Approved Septic System Plan
Howard County Health Department

PLAN TO ACC
 FOR B
 HARLE

DETAIL
1" = 20'

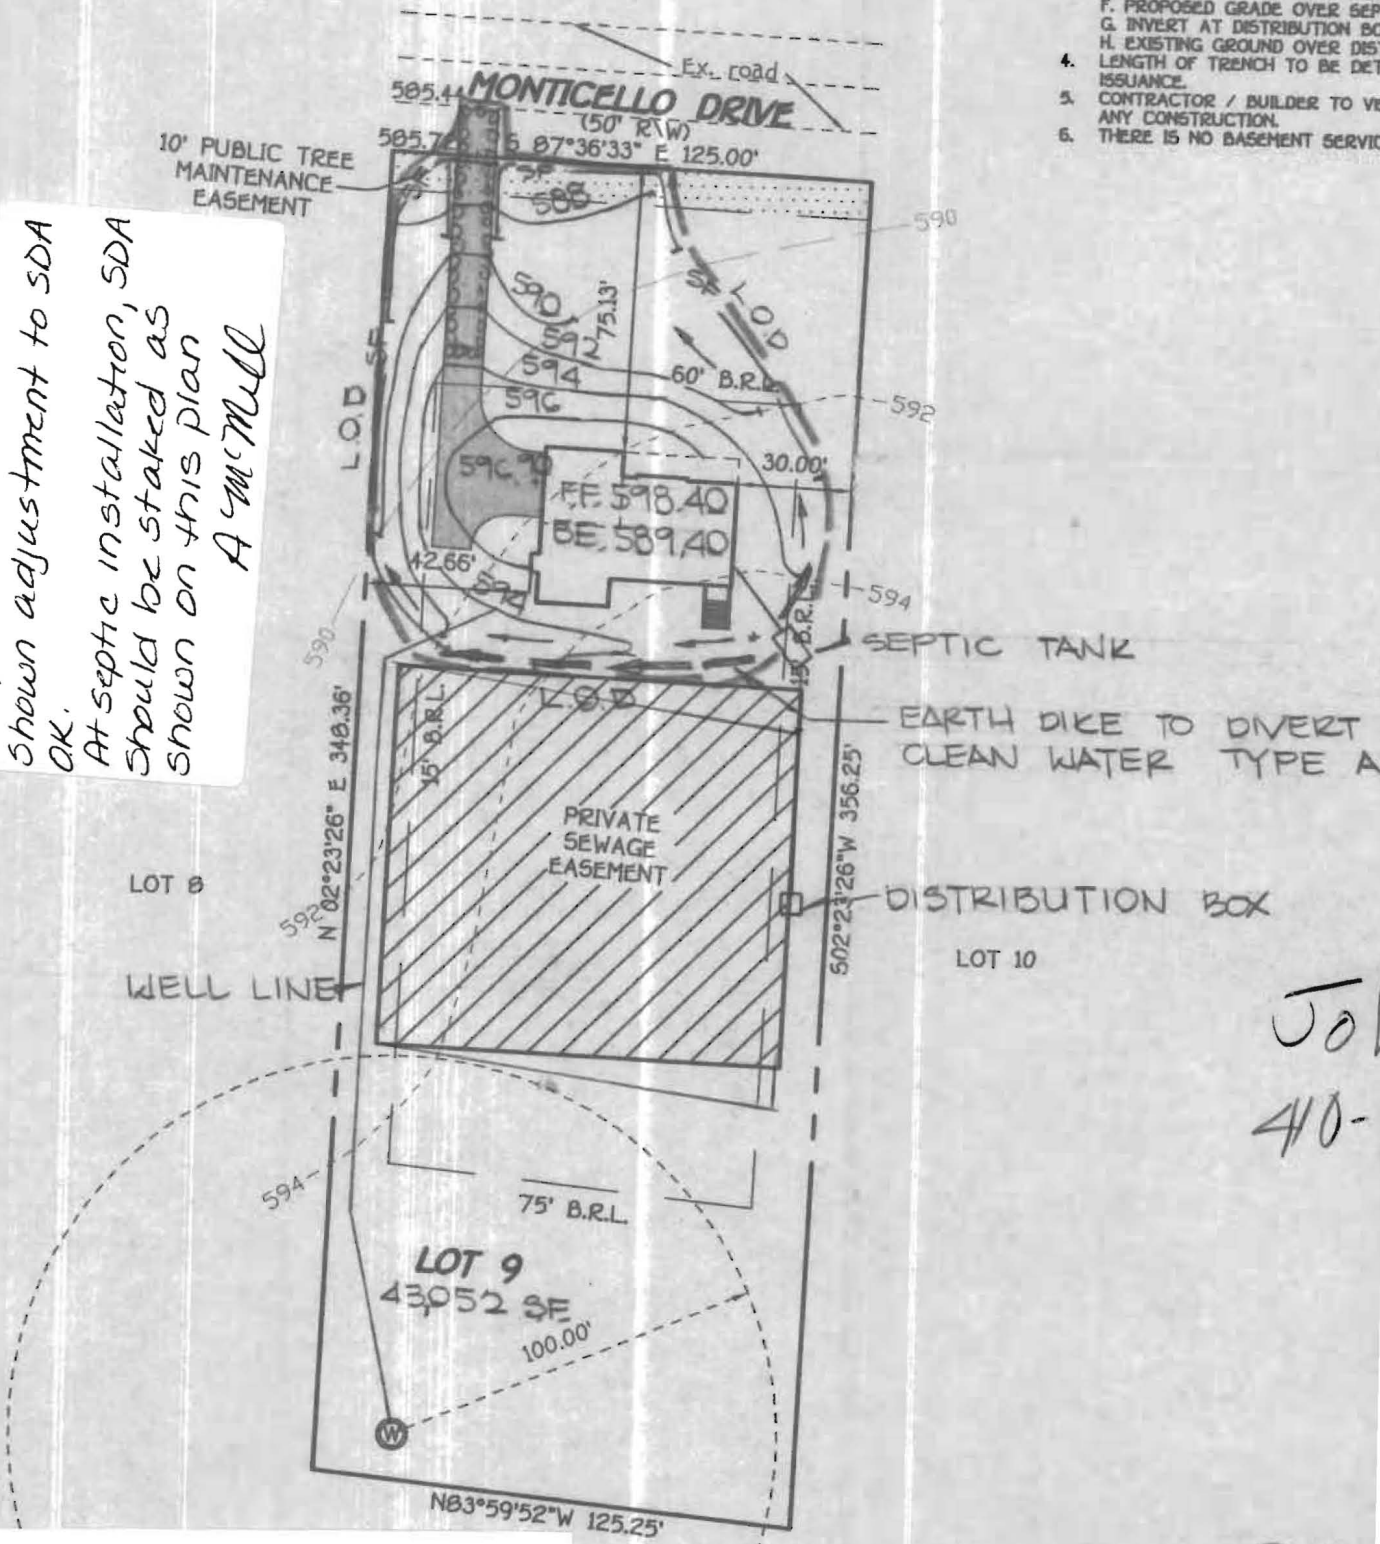
2/26/01
 Shown adjustment to SDA
 OK.
 At septic installation, SDA
 should be staked as
 shown on this plan
 A Y McMill
